**Re: Response to Draft Environmental Assessment (EA) Addendum
Mississauga Bus Rapid Transit (BRT) - (Eastgate Parkway at Highway 403 to Eglinton
Avenue at Renforth Drive)
Etobicoke Creek Watershed; City of Mississauga; Regional Municipality of Peel**

SUBJECT: Mississauga BRT
TO: Aimee-Rose Tupaz, P.Eng.
FROM: Stephen Schijns, P.Eng.
DATE: December 10th, 2008
COPIES: **MTO:** Jason White, Ted Lagakos, Martin Sedkowski, Clement Shim, Chris Tschirhart, Chris Blaney, Ram Dharamdial, Branko Zivkovic
GO Transit: Stephanie Davies, Muyiwa Adebayo, Jeff Bateman
Mississauga: Geoff Wright
MRC: Dale Turvey, Andrew Shea, Kevin Rodger
OUR FILE: 6964
SUBJECT: Response to MTO Comments on draft Preliminary Design Reports

| COMMENT | RESPONSE | Reference Section |

Figure 1: Utility Relocation Plan and intersection layout –
Winston Churchill Boulevard

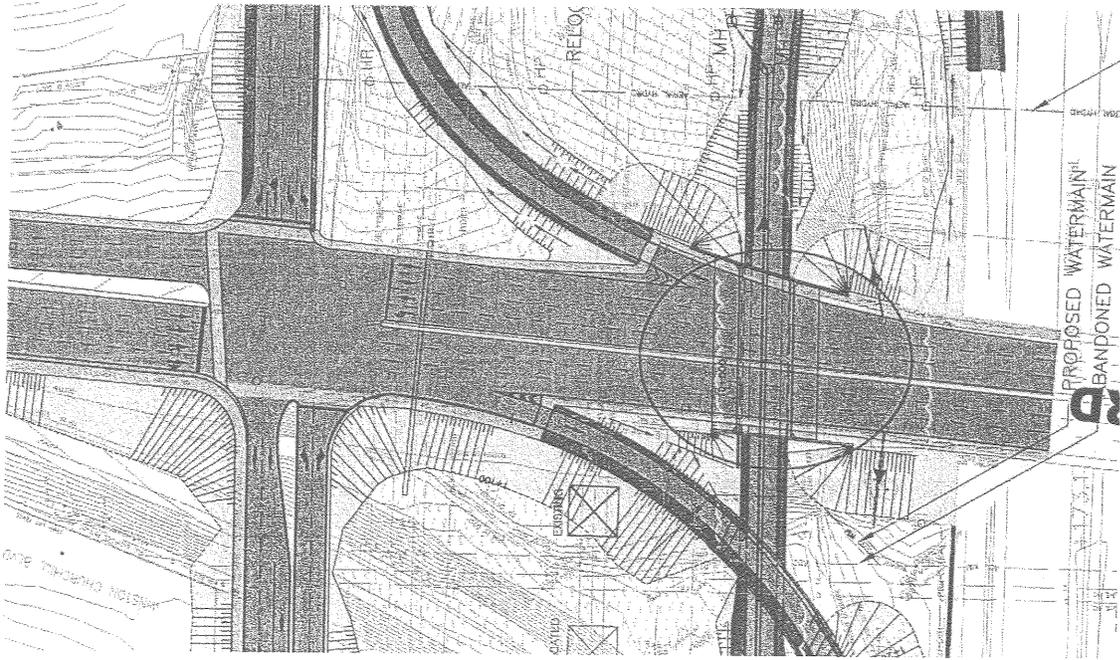
| General Comments for the BRT | Response |
|---|---|
| 14. Is it possible to obtain a copy of the revised drawing at the Winston Churchill and E-N/S ramp terminal intersection? | Attached as Figure 1. |

Figure 2: Noise Wall Plan between
Hurontario Street and Cawthra Road

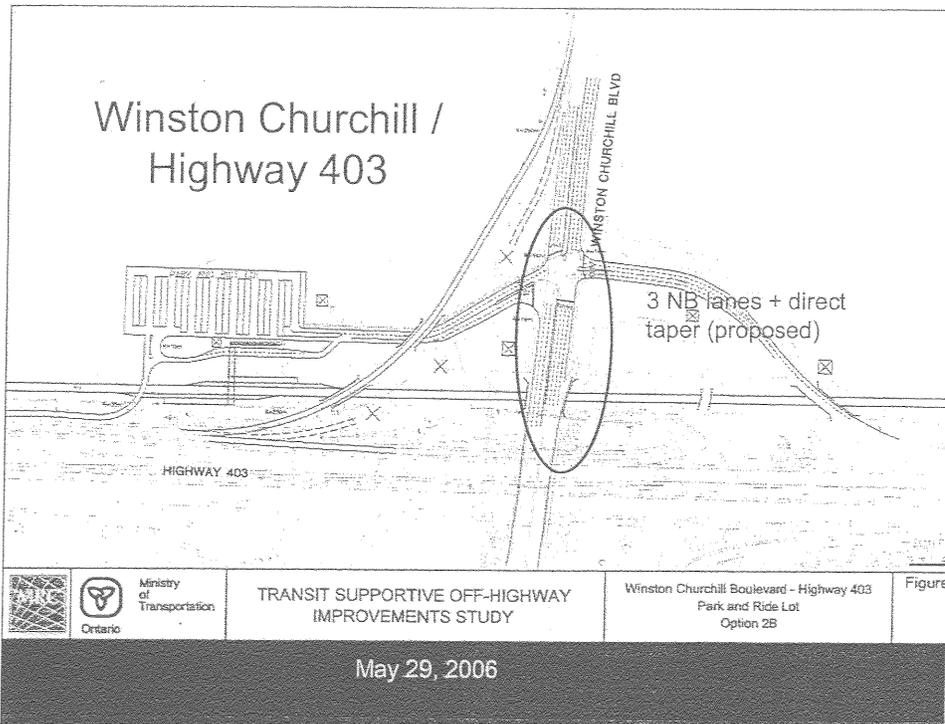
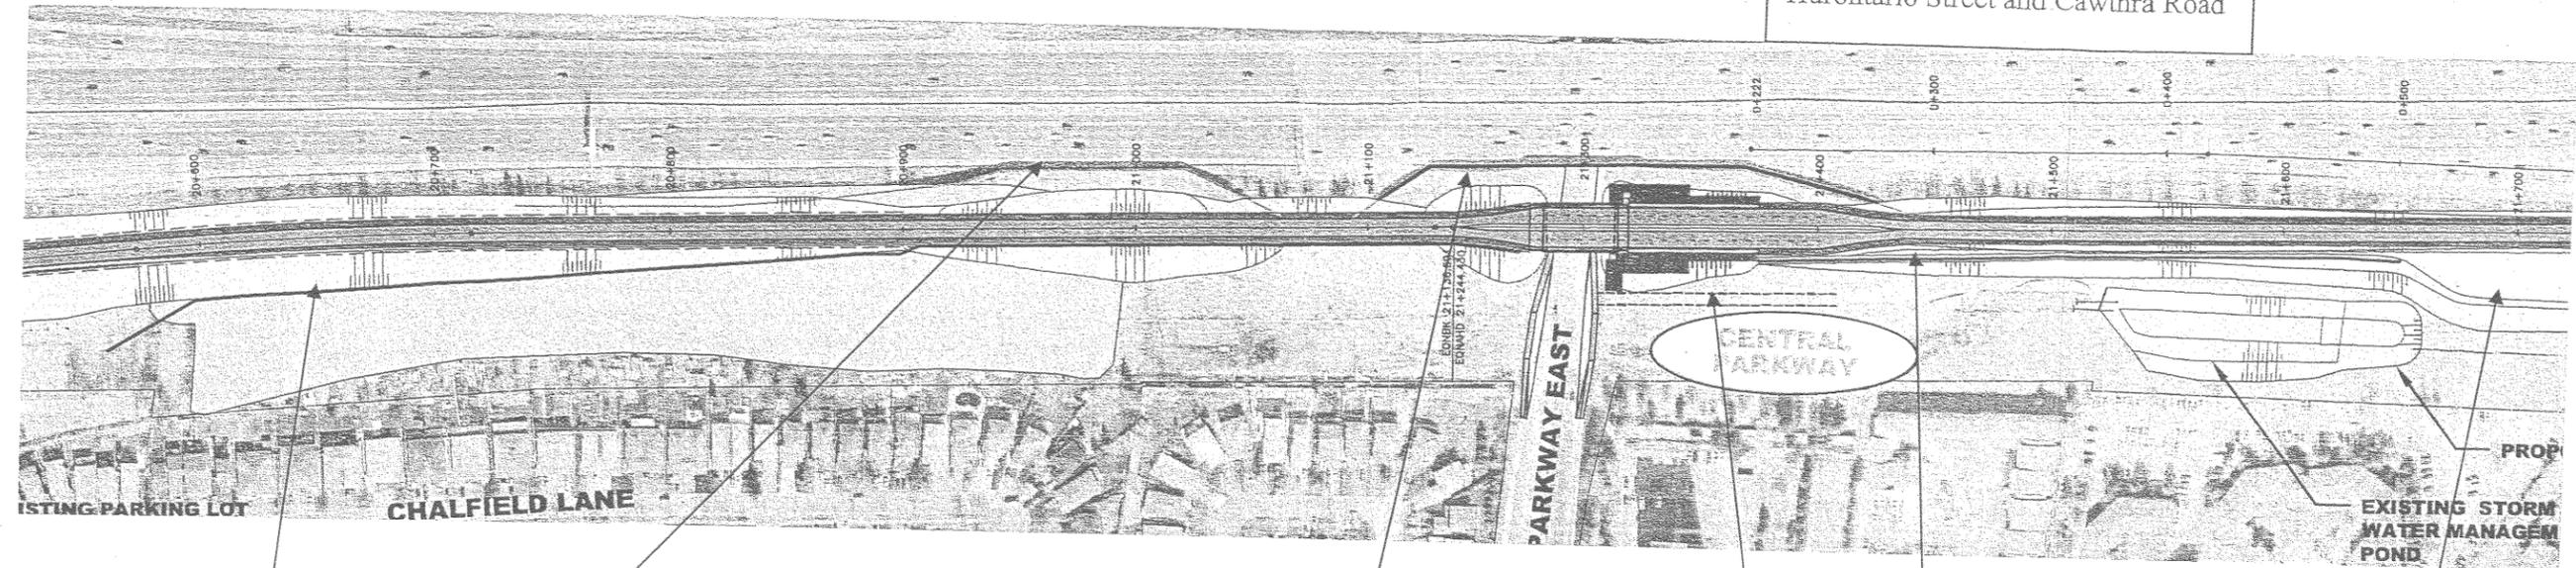
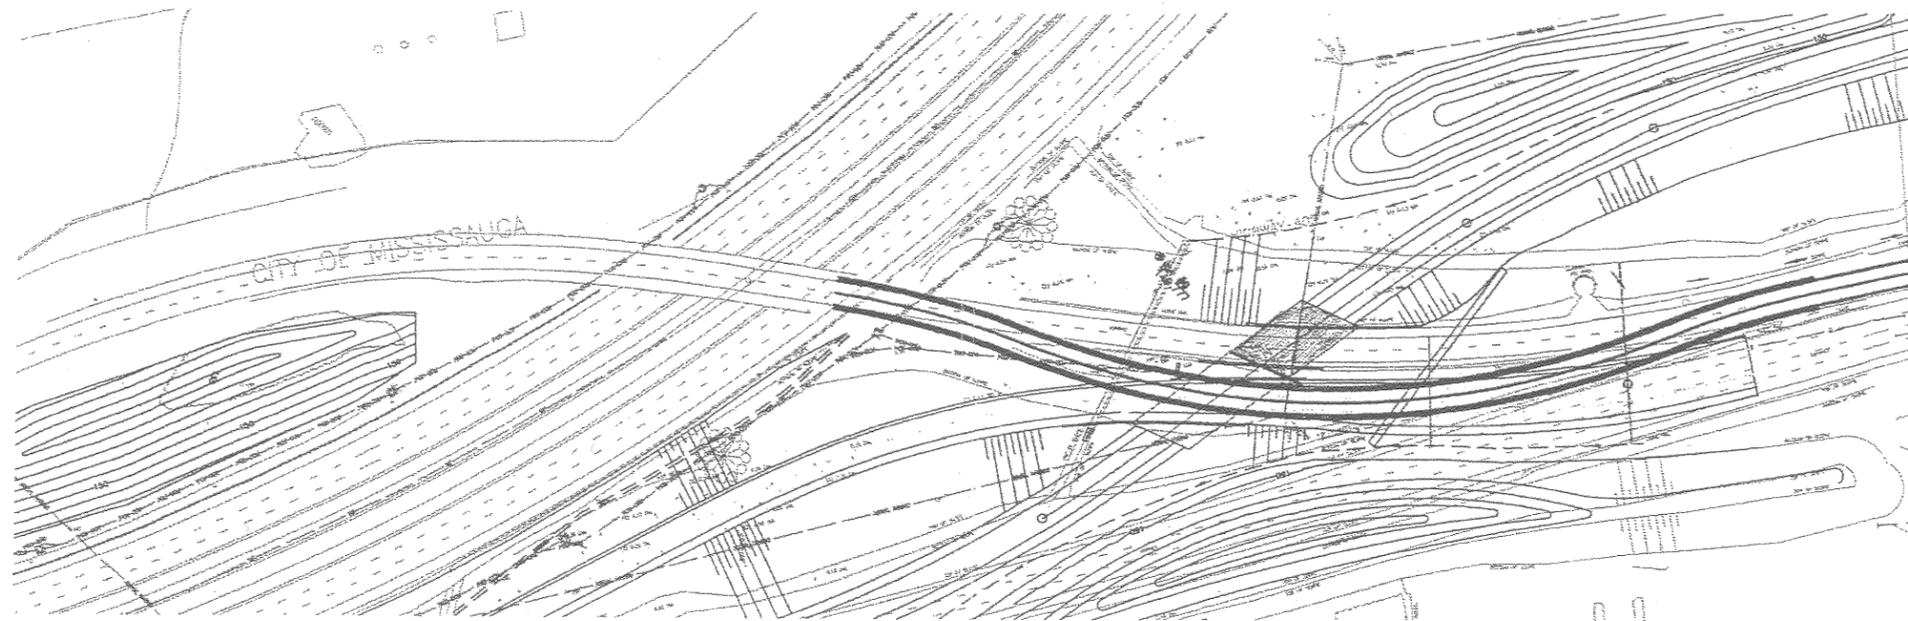
| General Comments for the BRT | Response |
|---|--|
| 5. The noise barrier wall shown in Figure 1 needs to be extended westerly | Noise wall adjusted. Revised plan illustrated in Figure 2. |

| General Comments for the BRT | Response |
|---|---|
| 6. Cross section C – C shows the noise barrier to be removed and the note on the plan shows the wall to be retained. Which comment is correct? | The existing Highway 403 noise wall at the Central Parkway crossing is to be retained only in the station area. Beyond that, the noise barrier will be replaced with a new noise barrier on the south side of the busway, as illustrated on Figure 2. |

Figure 3a: Detour Plan at Highway 403 Exit ramp to Eastgate Parkway – Two Stage Alternative

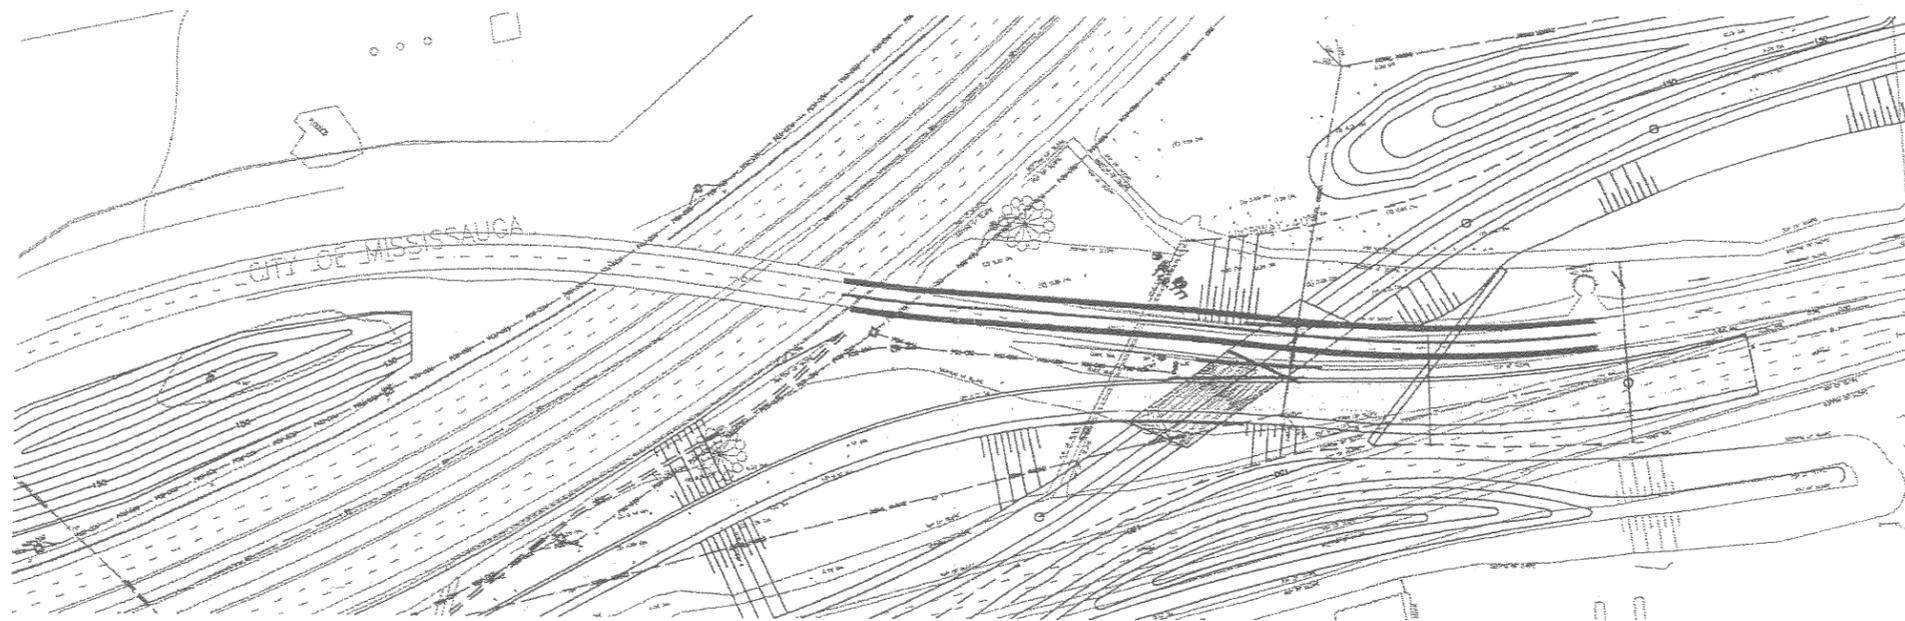
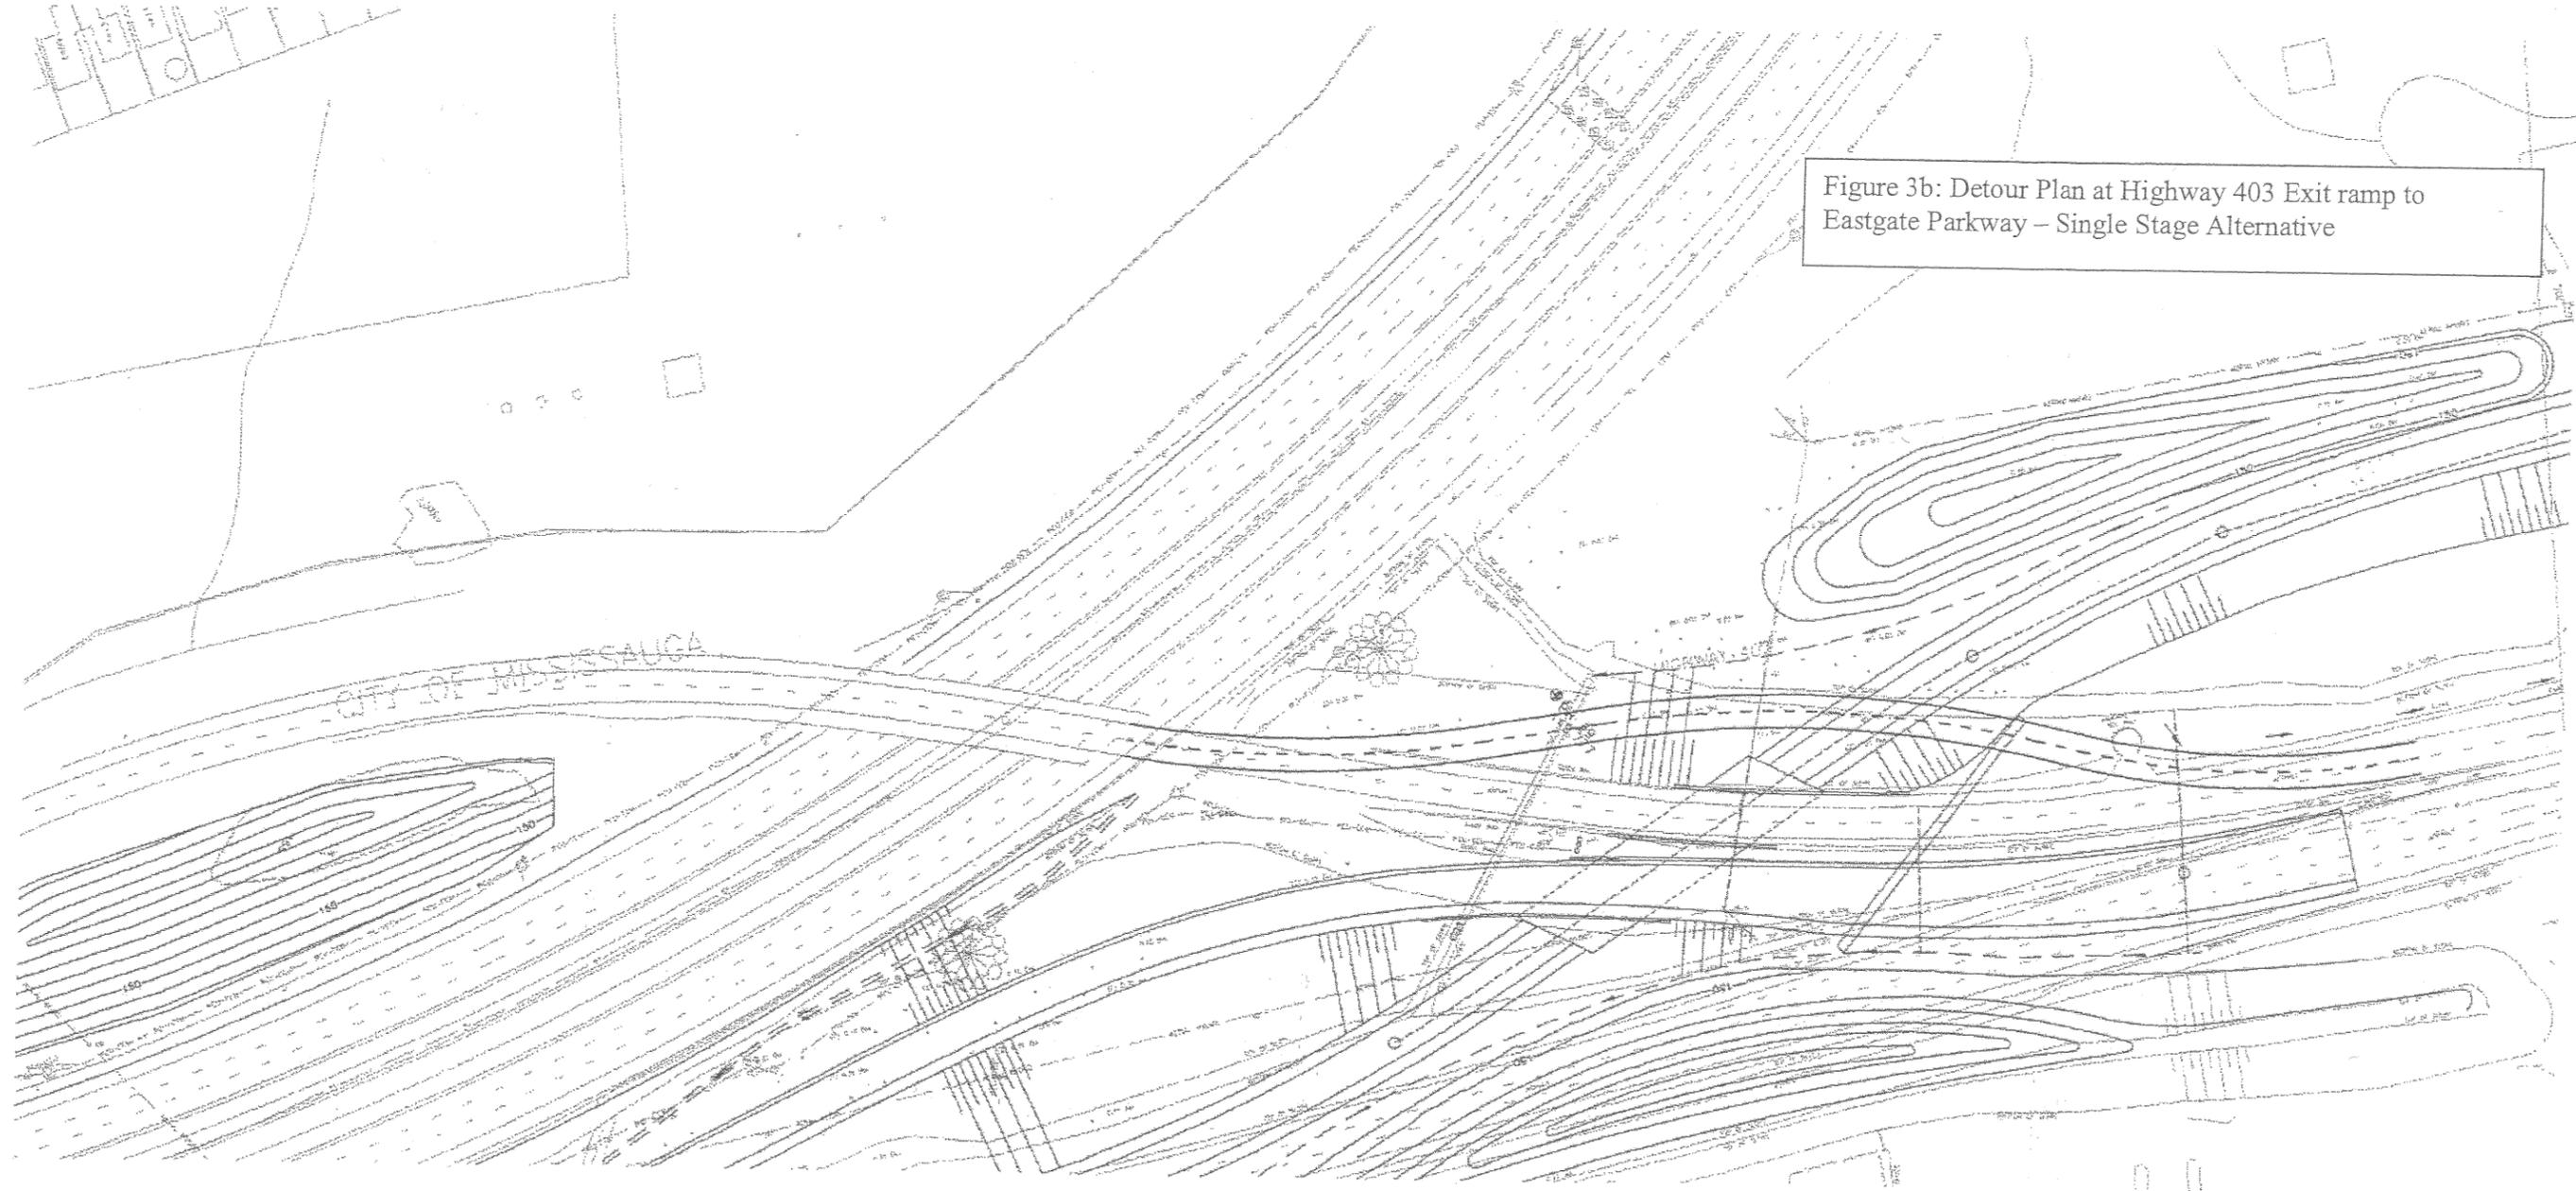
| General Comments for the BRT | Response |
|---|---|
| 10. Provide staging drawings for the Ramp realignment and structure construction. | Staging drawings are included in current draft of BRT East PDR (Nov-08). See Figure 3. |
